AMENDMENTS TO THE DRAWINGS:

REMARKS

**FIG. 4**

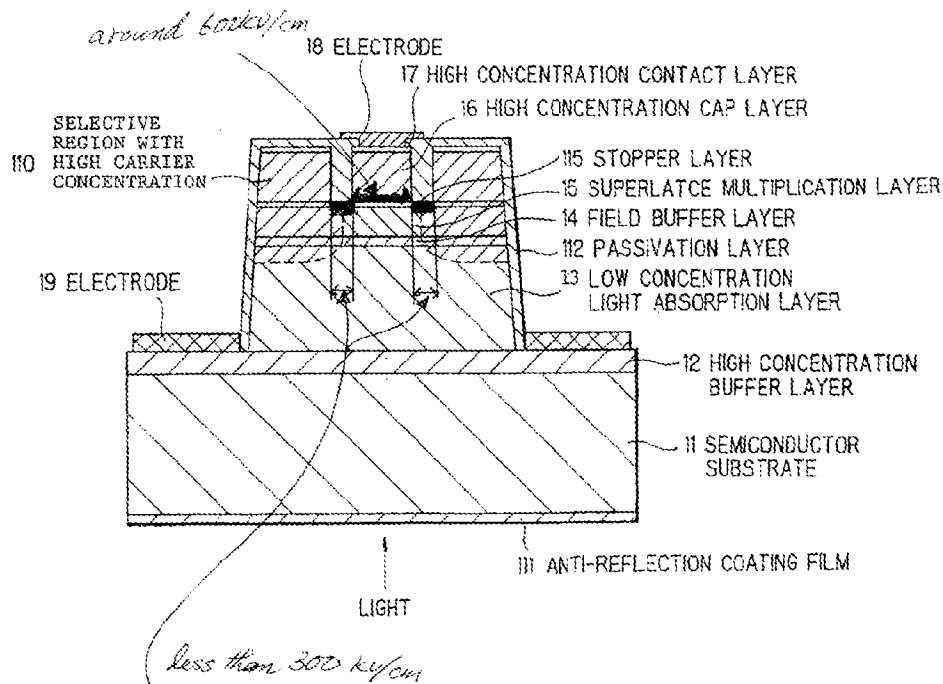
Hence, WATANABE only discloses that the lateral electric field intensity of this region, to which an electric field is charged, is less than 300 kV/cm. Referencing Fig. 4 of WATANABE as a concrete example, the region, to which an electric field is charged, corresponds to the surface of the etching stopper layer 115 or the multiplication layer 15 contacted to the passivation layer 112 (see Fig. 4, below; annotations added).

Further, WATANABE discloses that the electric field intensity is around 600 kV/cm in this region to which an electric field is charged but which is not in contact with the passivation layer (i.e., the surface of the etching stopper layer 115 or the multiplication layer 15 covered by the high concentration cap layer 16; see Fig. 4, above, annotations added).

One skilled in the art would readily understand that in both of the etching stopper layer and the multiplication layer, the region in contact with the passivation layer has the lateral electric field intensity of less than 300 kV/cm, while the region in contact with the  $n^+$  cap layer (i.e., does not contact the passivation layer) has the electric field intensity of around 600 kV/cm (see annotations to Figure 4, above).

In other words, the electric field intensity varies in the same etching or multiplication layer in WATANABE.
